Addendum #1

Project Name: NDOR Equipment Storage Building and Wash Bay
Gordon, NE
SHA Project No.: 13017
NDOR Project No.: AFE K-500 (Building No. 50905)
Issued: February 17, 2014

SHEET
E100

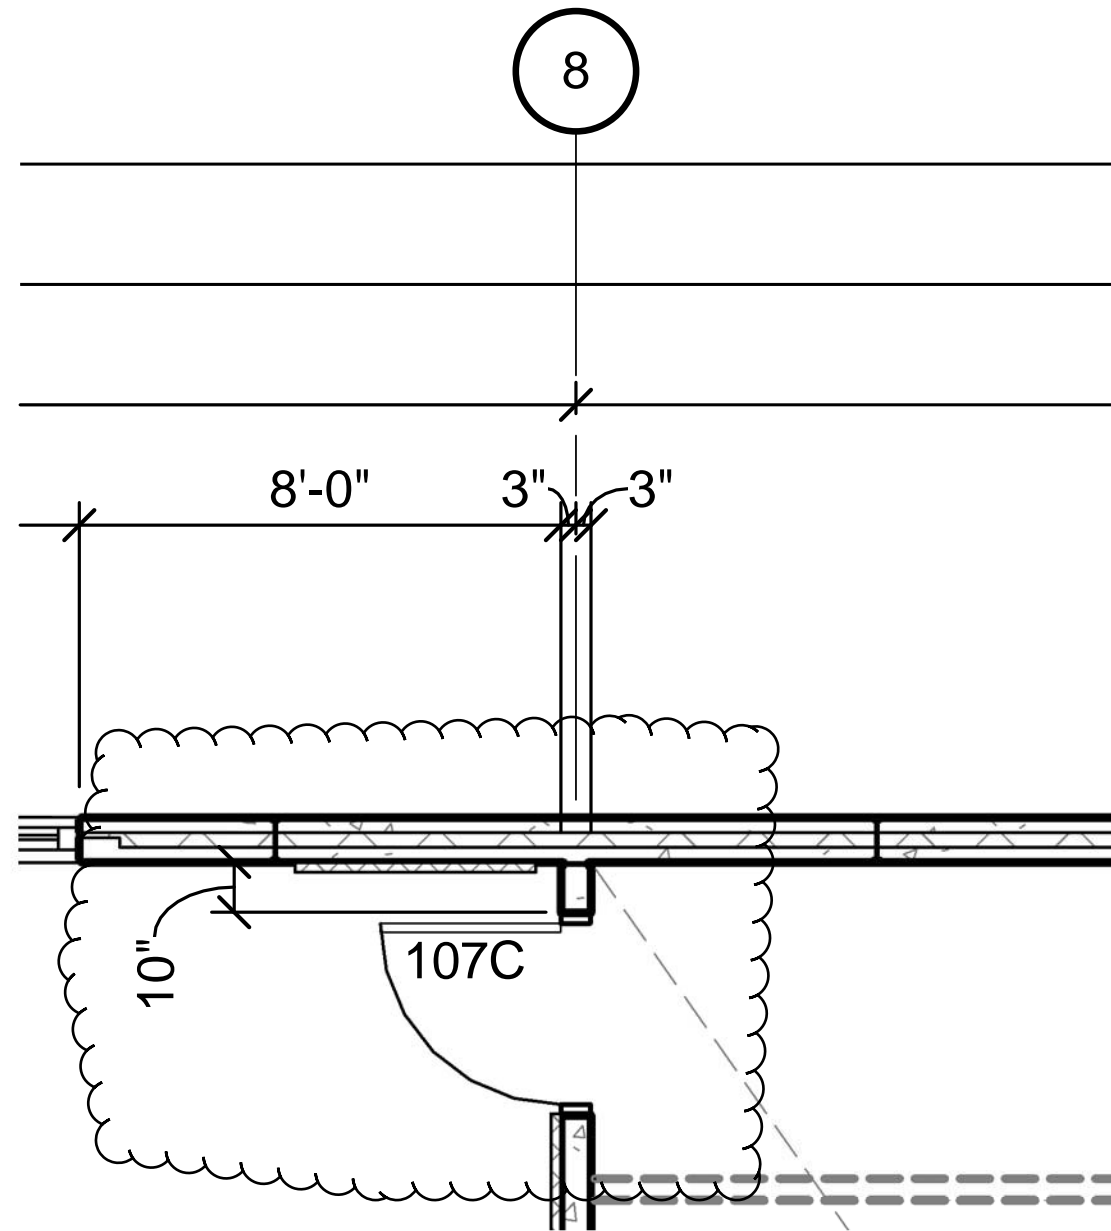
- ADD 1-4** Refer to sheet A100 –Floor Plan, Schedules and Door Types; make the following changes:
1. Add new door opening 107C at the north end of the wash bay/equipment bay demising wall (see attached sketch A1 for clarification).
 2. Add Door 107C to the door schedule. Door 107C shall be a duplication of Door 107B in every respect.
- ADD 1-5** Refer to sheet E100 – First Floor Plan – Lighting; make the following changes:
1. Add exit sign and wall switches in Wash Bay 107 @ door opening 107C and add exit sign in Equipment Bay 106 @ door opening 107B (see attached sketch E100-1 for clarification).
